SCI-823-0.00
PID Nos. 19415, 77366, 79977

Value Engineering Study Report
Draft Stage 2 Design Phase

re: SCI-823-0.00, PID Nos. 19415, 77366 and 79977, Portsmouth Bypass
Harrison, Jefferson, Madison and Porter Townships, Scioto County
Value Engineering Study Report

ALIGNMENT: TANGENT

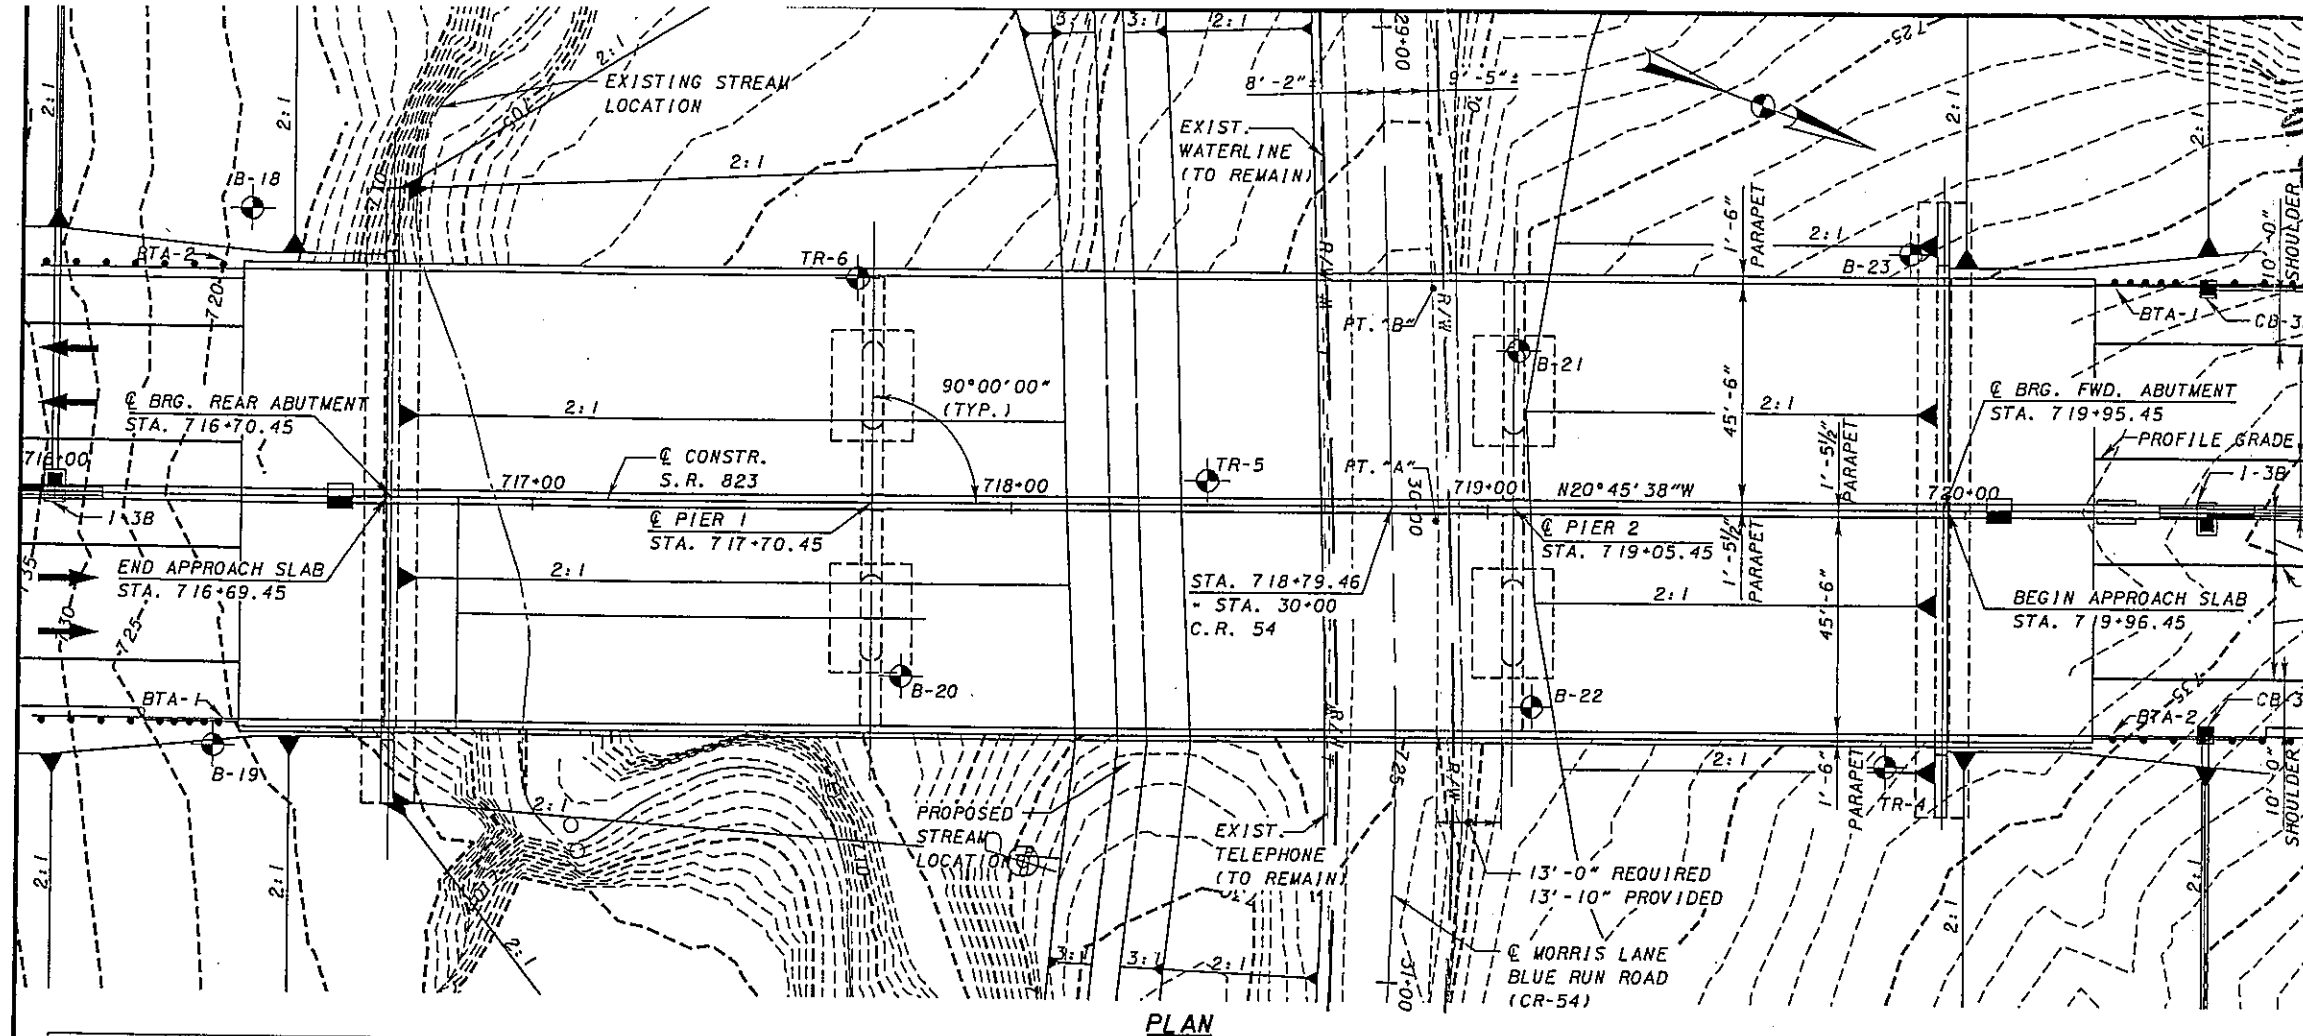
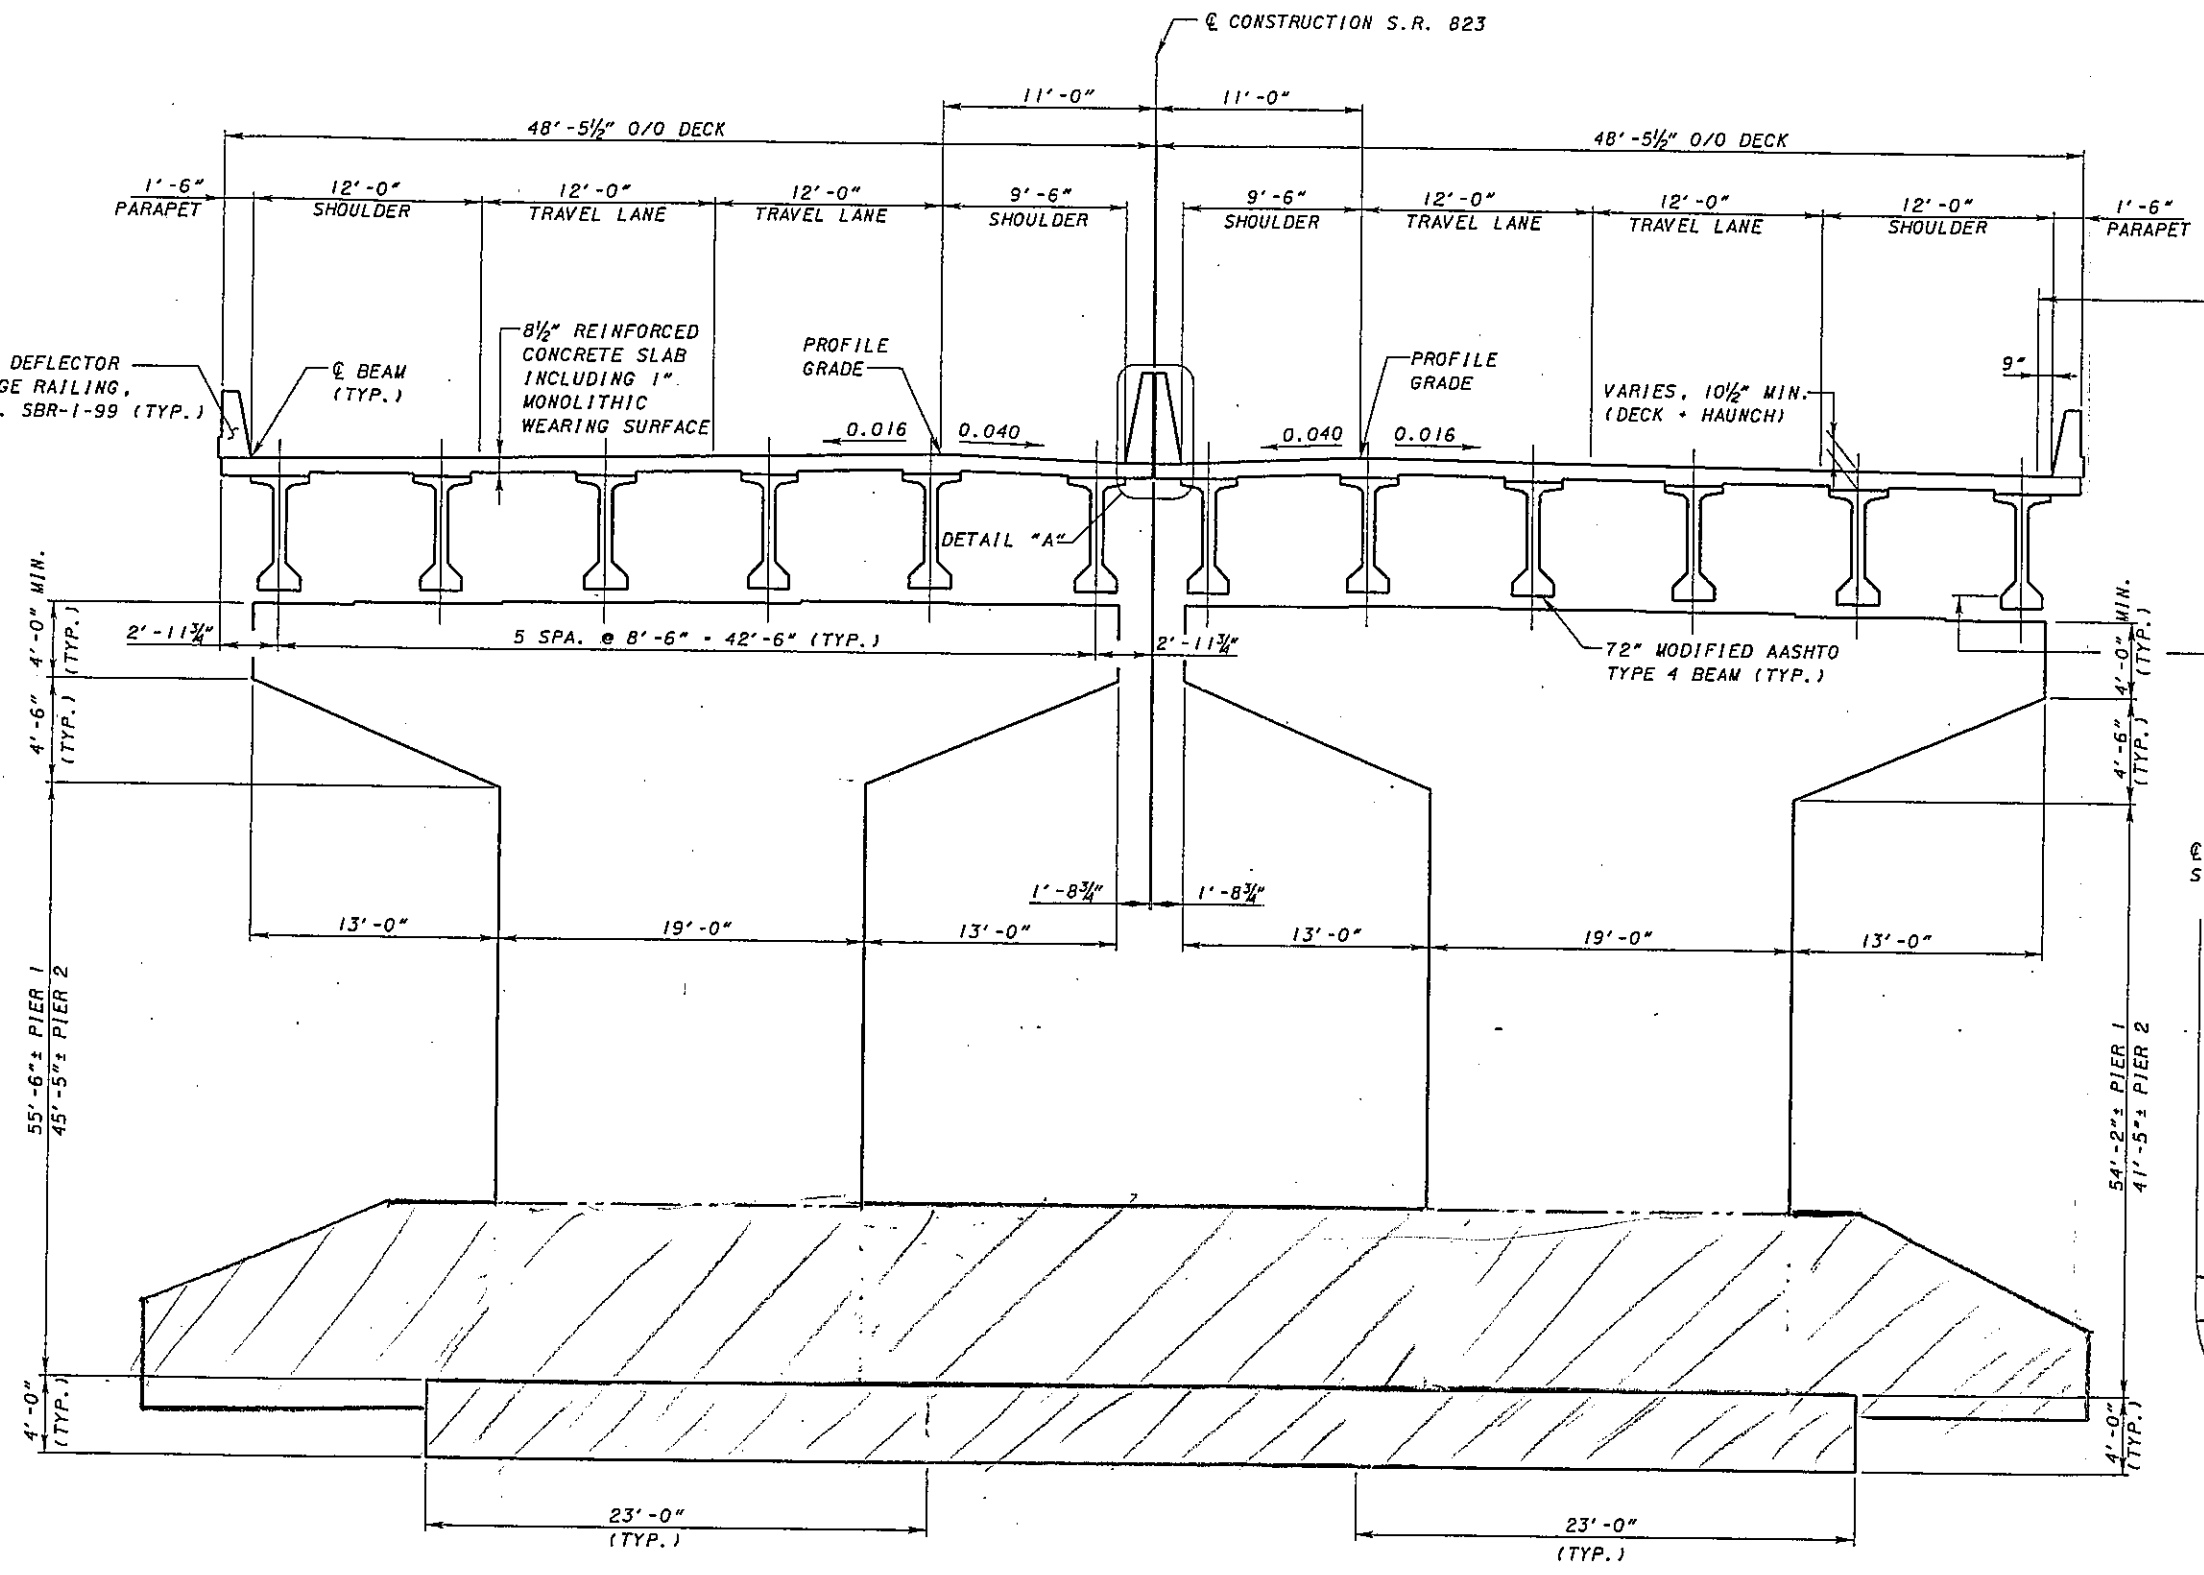
- SCI-823-1018 L&R – Site Plan
- SCI-823-1018 L&R – Pier Details
- SCI-823-1357 L&R – Site Plan
- SCI-823-1357 L&R – Pier Details

- Revised SCI-823-1018 L&R – Site Plan
- Revised SCI-823-1018 L&R – Pier Details
- Revised SCI-823-1357 L&R – Site Plan
- Revised SCI-823-1357 L&R – Pier Details

SR823
TYPICAL ROCK CUT NORMAL SECTION

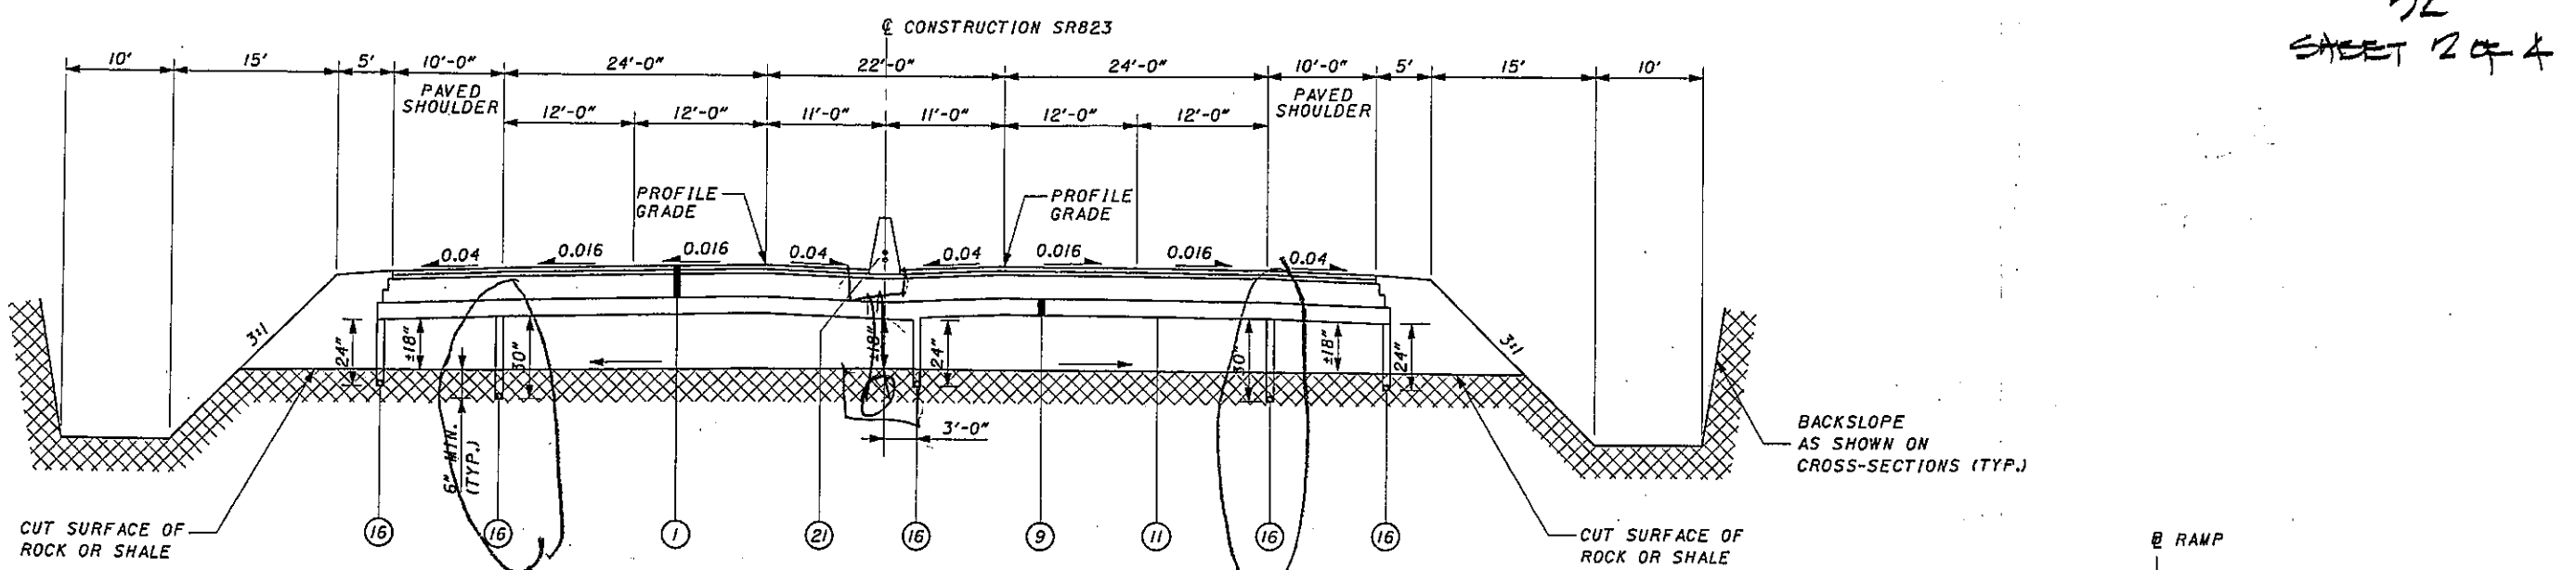
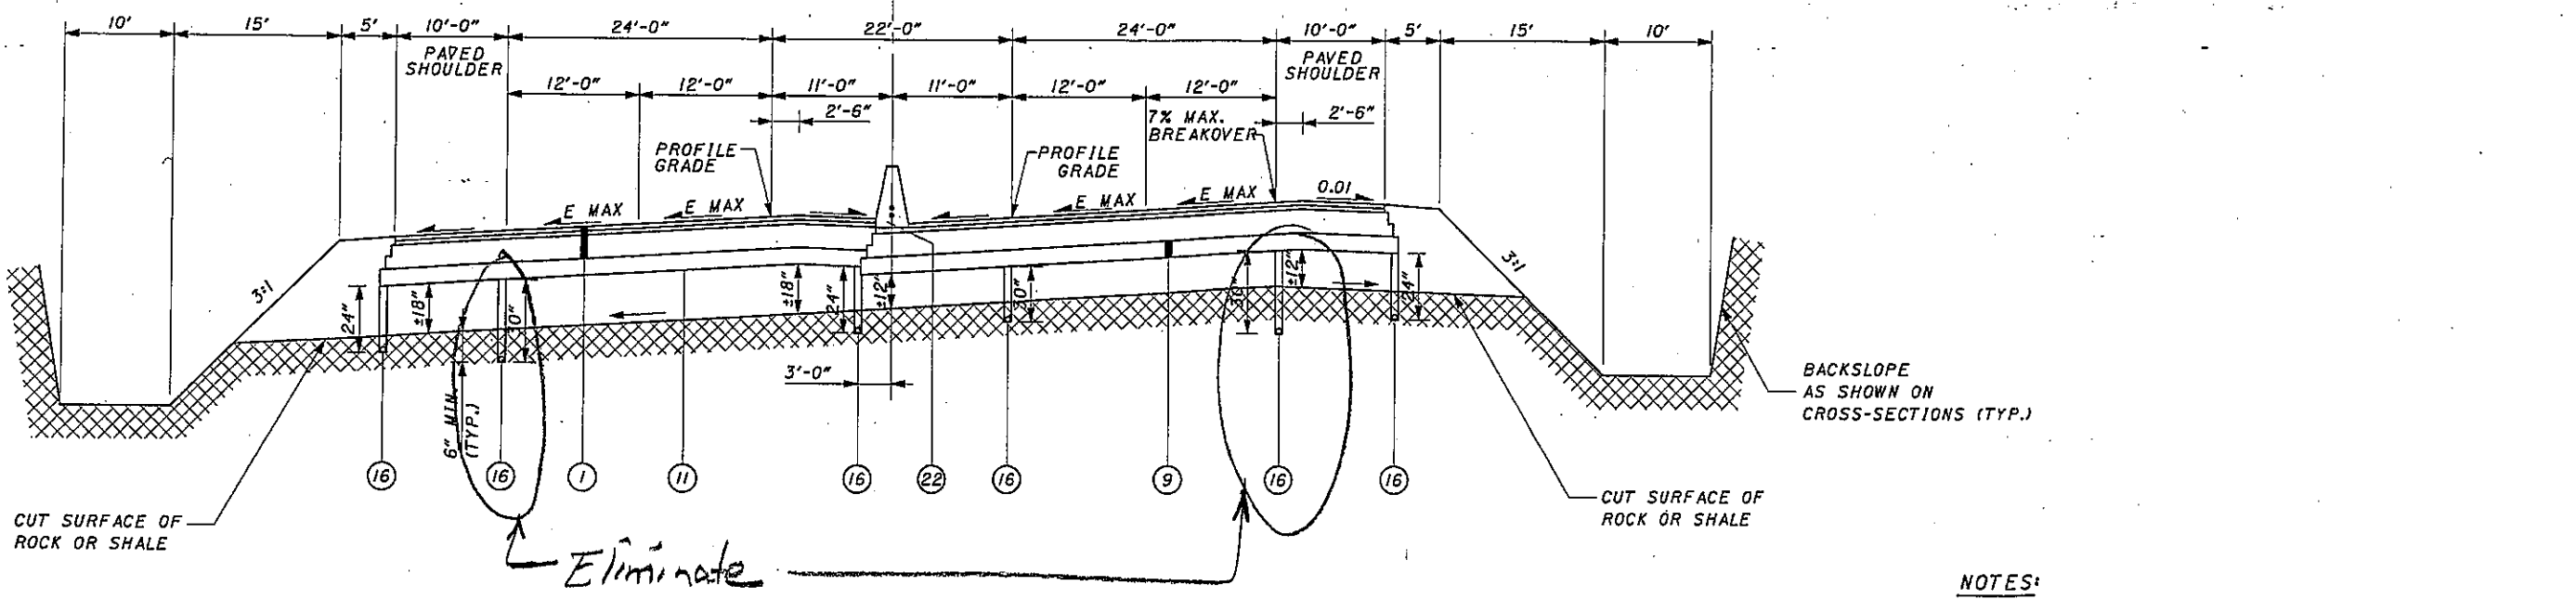
Given the large quantity of durable rock, construction of a graded 3-ft.-thick "rock blanket" or "rock subgrade" immediately below subgrade will provide a continuously drainable subgrade, eliminating underdrains that will likely be installed in rock fill at the top of embankments or in rocky backfill thru rock cuts. This blanket or subgrade would consist of durable rock meeting a specification, which would be developed to describe quality, gradation and compaction requirements but would be practical and allow use of anticipated readily available sandstone on the project. For example, the specification could call for gradation of the rock in the lower 24 in. of the blanket to be no greater than 6 in. and contain no more than 5% fines by visual examination. The final 12 in. could be no greater than 2 in. in size with a similar maximum % fines.

In embankments, this 3-ft. zone or blanket would be placed at the top of the rockfill or random embankment placed using conventional specifications, and would begin 3 ft. below subgrade to provide a suitable finished grade in at the subgrade surface.

The detail for construction and the specification would call for grading of the surface at the base of this blanket to drain toward outlet slopes or ditches. In the cuts, the base of the undercut would be graded, as much as practicable, to allow free flow to the adjacent ditches.
